### **REMARKS**

Attachments: Corrected and Replacement Drawing Sheets  
(Sheet 1 / 3, and Sheet 2 / 3)

**Amendments to the Drawings:**

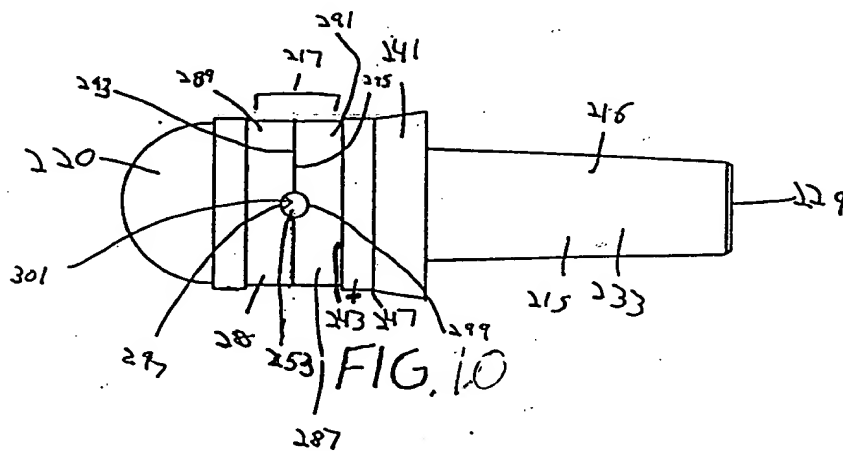
The Examiner objected (Action, Para's 3, 4, 5, and 6) to the drawings for reasons given. First the Examiner objected to the reference characters "16" and "50" and their designation. Second, the Examiner objected to the numbers of FIGS. 8 and 9 as being incorrect.

FIG. 1: delete the arrowhead on the leadline for “16”, add an arrowhead at the end of the leadline for “17”; and clarify the exterior contour “69” and “71” of the driving band “17”.

By this Reply, FIGS. 1, 2 and 3 and the Specification are amended in a manner to clarify the elements "16" and "50" and the use of the terms rearward end portion, rearward leg, first leg, forward end portion, forward leg, and first leg.

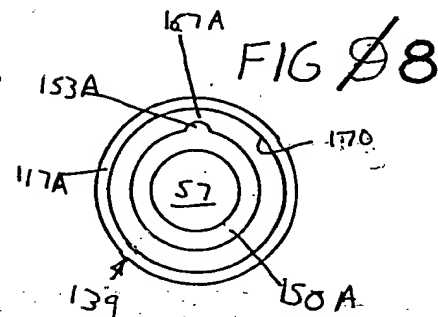
FIG. 2: change the numbers “16” and “15” to read “15” and “16”; change the number “74” to read “57” for the forward cavity in the leg “50” of the projectile body “11”; add the number “74” and a lead line pointing therefrom to a chamber in the insert member “19”; add the number “21” and a leadline pointing therefrom to the dome shaped wall of the nose “20”; add the number “25 and a leadline pointing therefrom to the interior surface of the nose “20”; delete the number “24” and the leadline therefor; and add the number “23” and a leadline pointing therefrom to a cylindrical annular surface of the interior wall “25” circumjacent to the open end of the nose “20”.

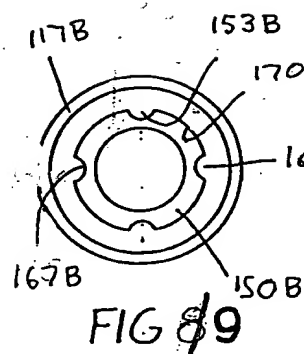
FIG. 3: change the numbers “16” and “15” to read “15” and “16”; place an arrowhead at the end of the leadlines from “17” and “19”; shorten the end of the leadline from “54”; and delete the number “74” and the leadline therefore.

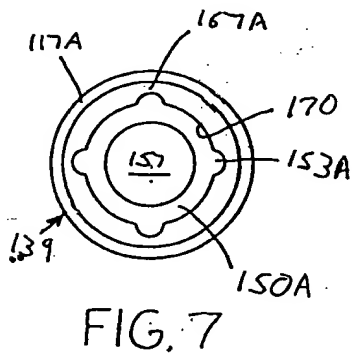
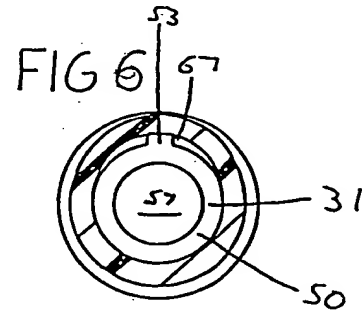
FIG. 4: replace the number “17” with “63”; add a number “17” and a leadline pointing therefrom to the drive band; shorten the leadline from “41” to point to the tapered surface; and shorten the leadline pointing to the forward leg “50” and end the leadline with an arrowhead.
